**AGENDA**  
**City of Monona Plan Commission**  
**Monona Public Library - Municipal Room**  
**1000 Nichols Road, Monona, WI**  
**Monday January 9, 2017**  
**7:00p.m.**

**B. Public Hearing on Request by Phil Troia, PDQ Food Stores Inc., Represented by Dan Bertler of Supreme Structures, Inc. for a Zoning Permit, Site Plans, and Building Elevations for Redevelopment of the Sites at 105 E Broadway and 6400 Monona Drive for a new PDQ Convenience Store, Two-Bay Car Wash and Gas Canopy with 10 Fueling Dispensers.**

**PLAN COMMISSION STAFF REPORT  
CITY OF MONONA**

EXTERIOR ELEVATIONS

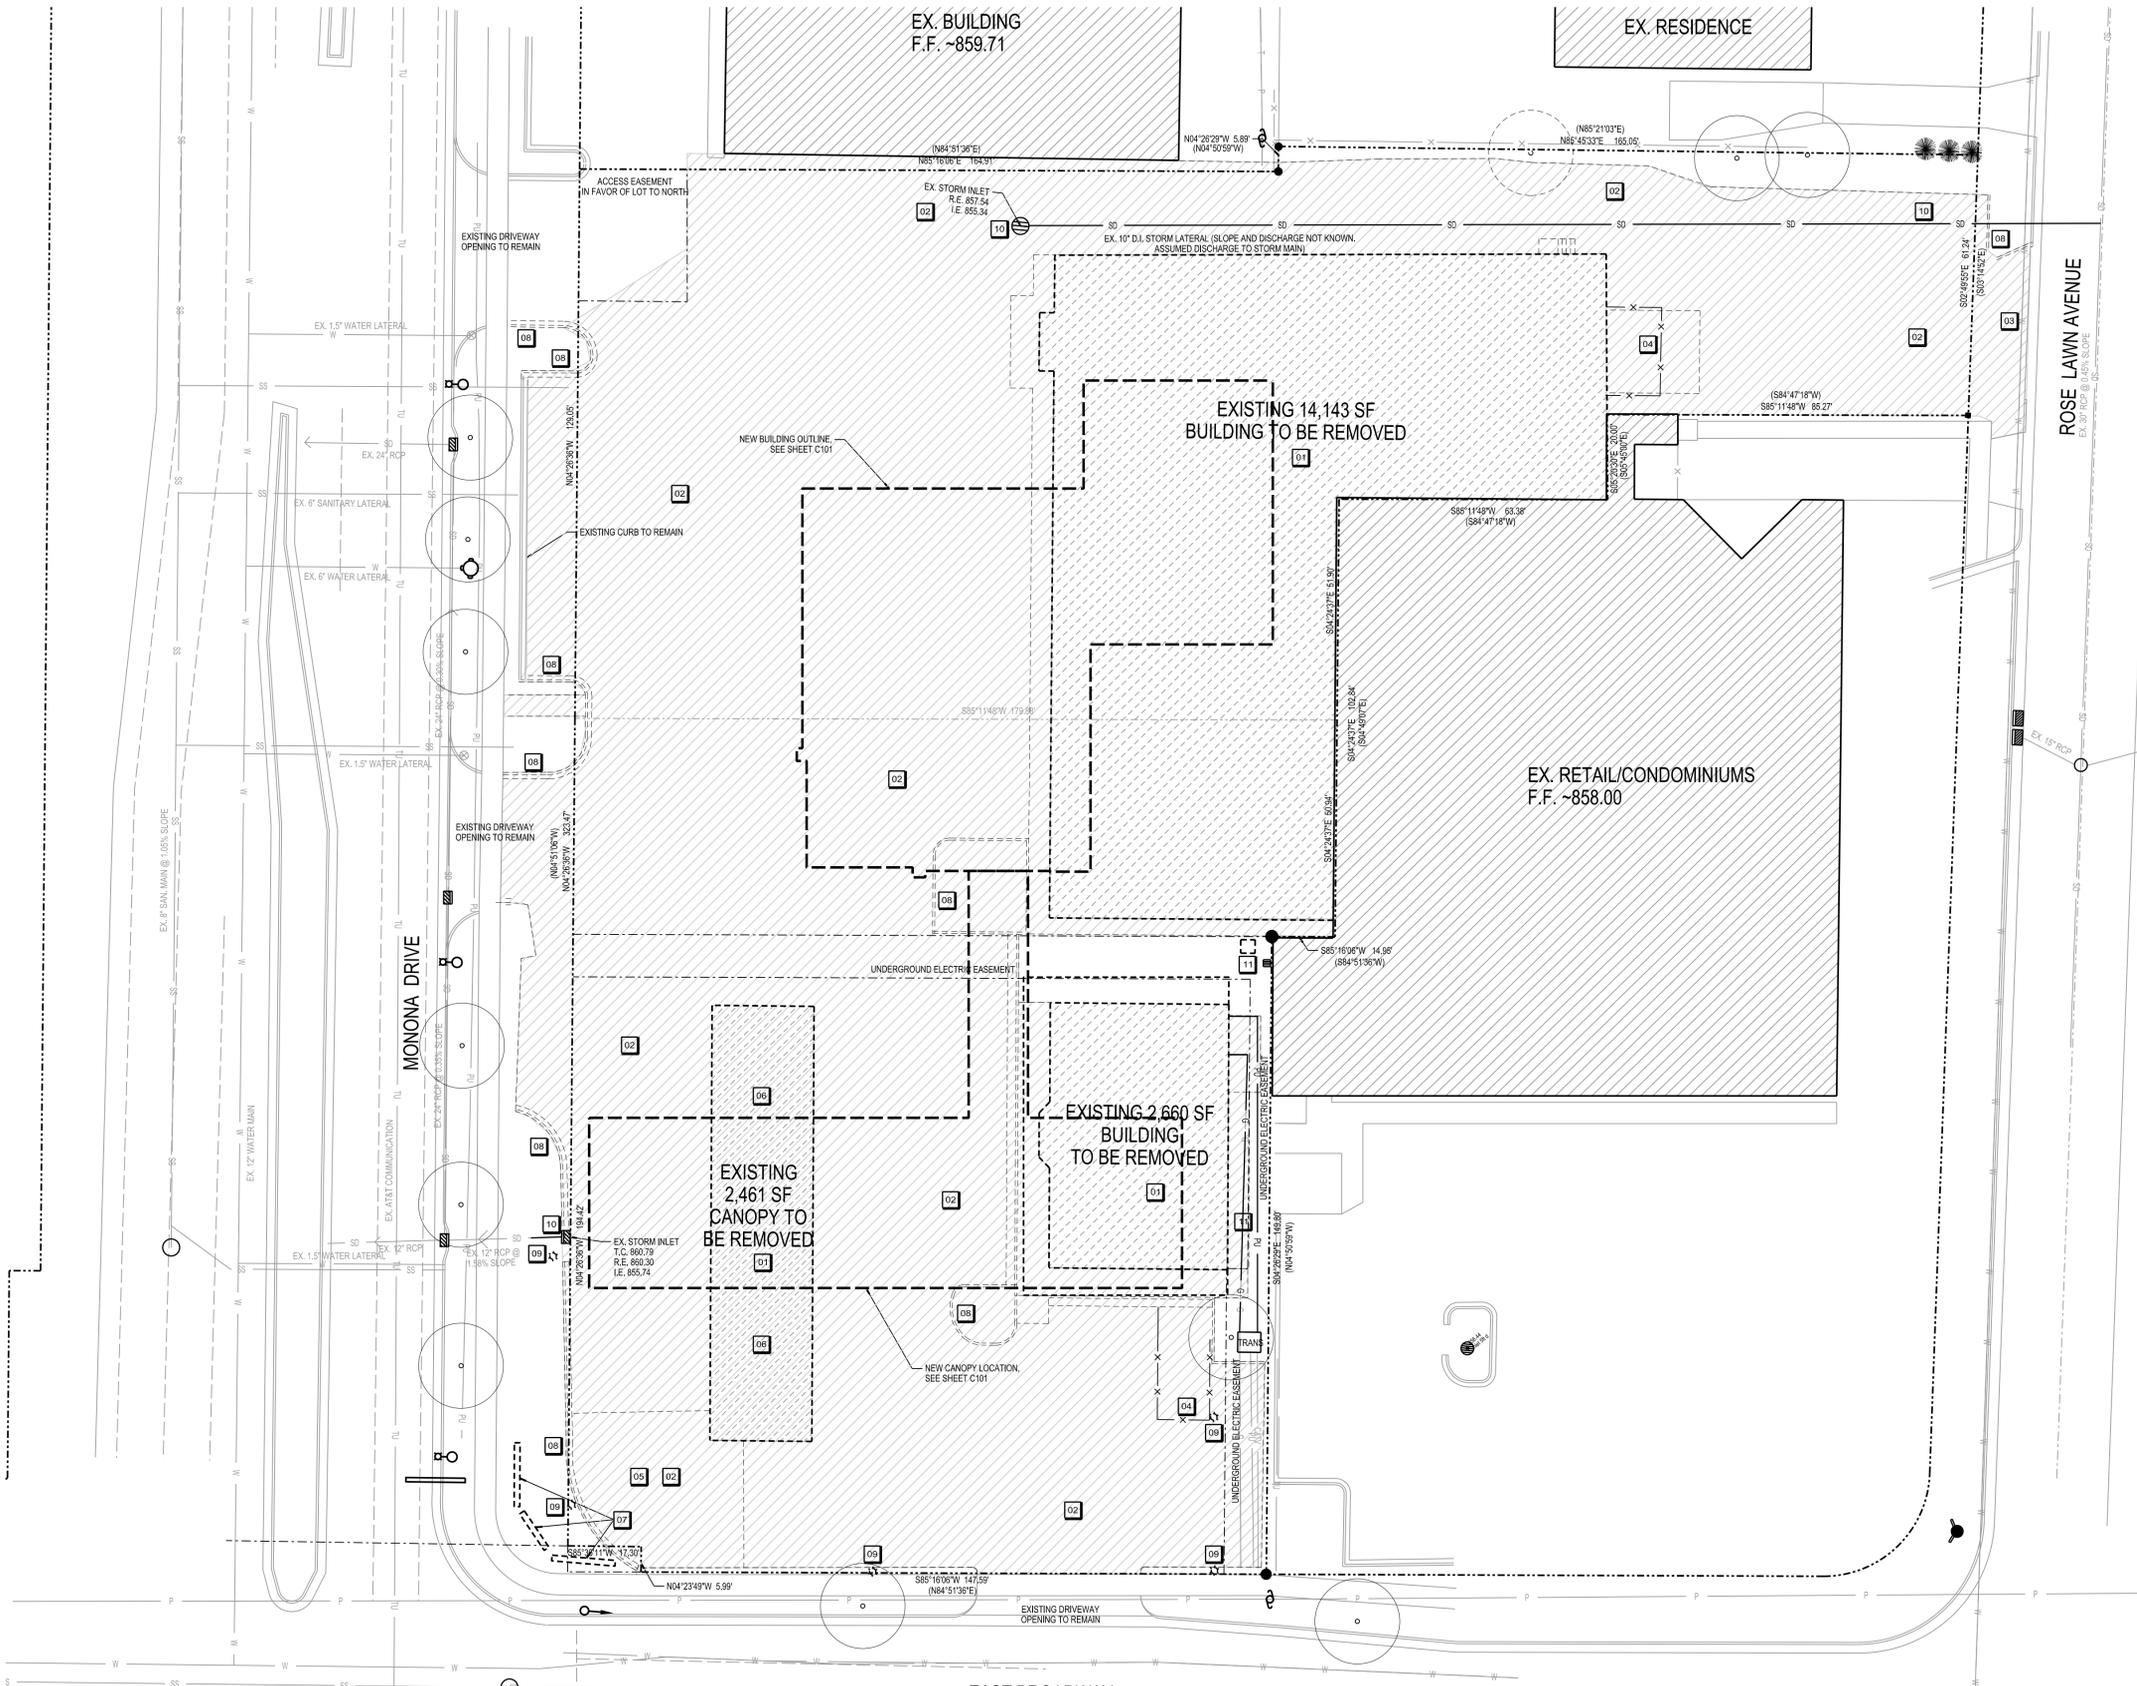
- i. **The outdoor trash area should be screened with an extension of the buildings architecture or an attractive fence or landscaping.** Per the West Elevation on plan sheet A401, it appears that the building wall is to be extended around the dumpster area in compliance with this requirement.

**03 STONE TRACKING PAD DETAIL**  
C801 SCALE: NOT TO SCALE

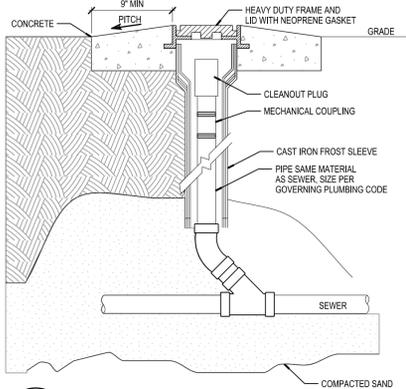
- c. Review Comments:
  - i. The Stone Tracking Pad shown in Detail 03/C801 should be changed to show a minimum width of 24 feet (the full width of the egress point), and WisDOT Type R geotextile fabric should underlie the stone tracking pad regardless of the status of the water table per the "Stone Tracking Pad" requirements of the Dane County Erosion Control and Stormwater Management Manual.
